Further Development of a Quarry

Application for substitute consent under Section 261A of the Planning and Development Act 2000 as amended.

Laurence Behan, Windmill Hill, Rathcoole, Co. Dublin

Figure 1: Location and distance between the nearest part of the subject quarry and the end of the nearest runway at Casement Aerodrome

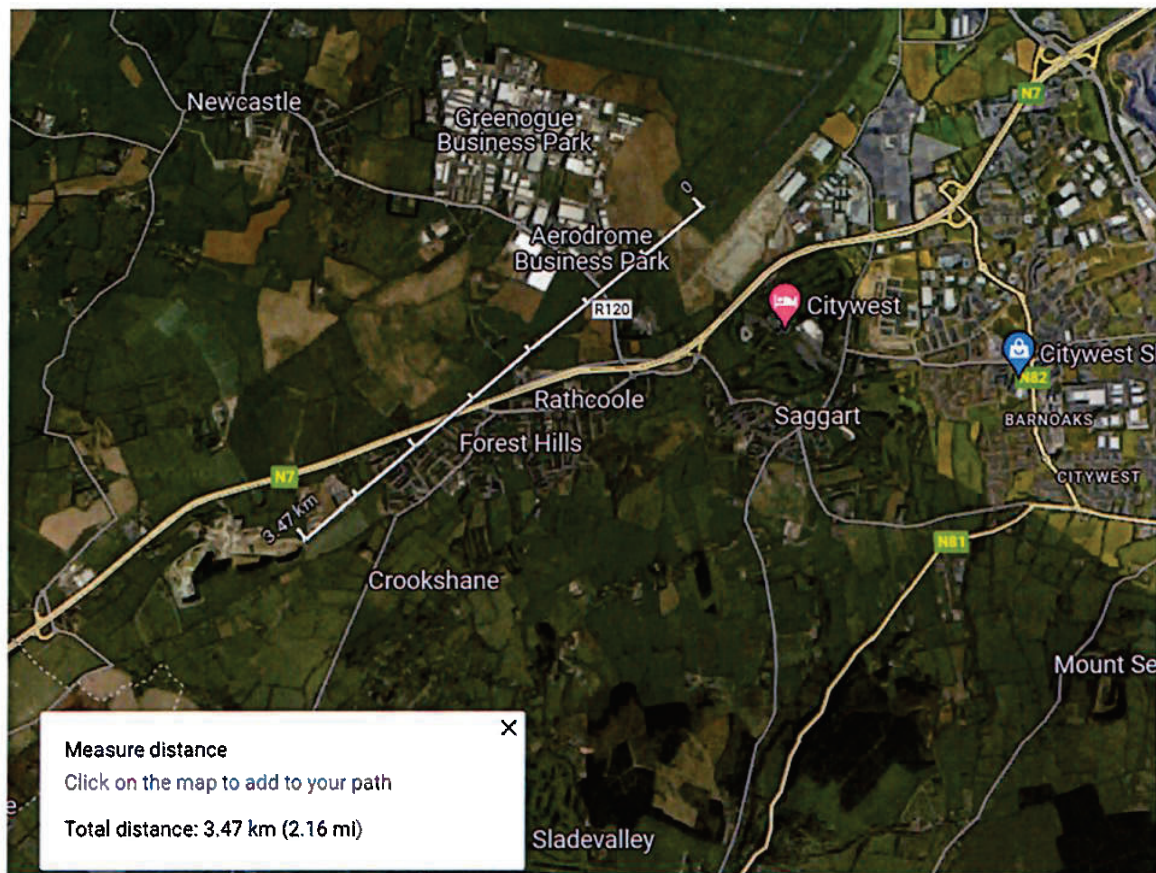
'Due to the proximity to Casement Aerodrome and to low level routes, Military Air Traffic Services requests an Aviation Impact Assessment on all potential effects on Irish Air Corps flight operations.'

It should also be clear from Figure 1 above that the quarry the subject of this s261 application is not located on the direct flight path of either of the 2 no. runways present at Casement Aerodrome. We would therefore contest the expressed view of the Department that the subject quarry is in any way proximate to the aerodrome or either of its runways, even the nearest one to the quarry, the subject of our client's application to the Board.

As can be seen from Figure 1 above, more directly aligned with the direction of the run way is the village of Rathcoole and the intervening housing estate at Forest Hills

Cross Section S261A RFI - A_A'

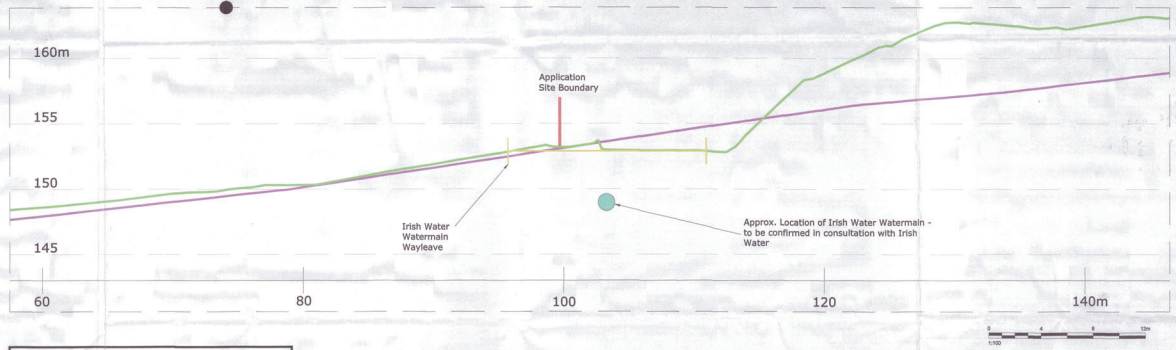
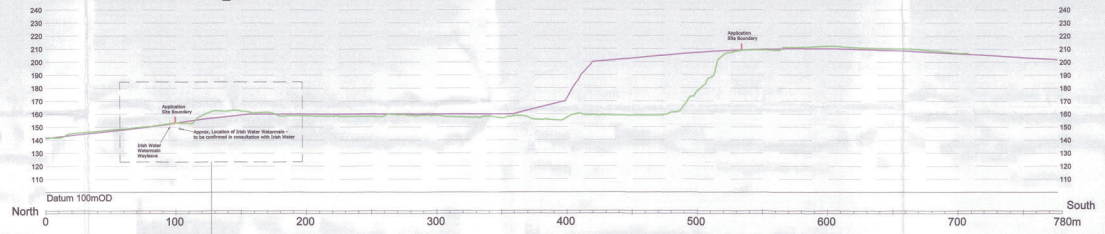
Item 9.2.15: The proposed development is in close proximity to a 1270mm concrete public watermain which runs through the site from west to east. The applicant is required to submit a drawing in plan and cross-sectional views which clearly shows the distance between all existing and proposed structures and the public watermain as well as existing and proposed cover levels over the watermain. The applicant shall engage with Irish Water's diversions section to assess feasibility of existing design and determine what the required separation distance is from the existing public watermain traversing the site. The outcome of this engagement with Irish Water's diversions shall be submitted to the planning authority as a response to Request for Further Information.

Approximate locations of the watermain have been indicated on the cross section supplied with this response, (located in Appendix B). Precise locations and other information requests with Irish Water will be identified through engagement with the applicant as part of the s37L application process.
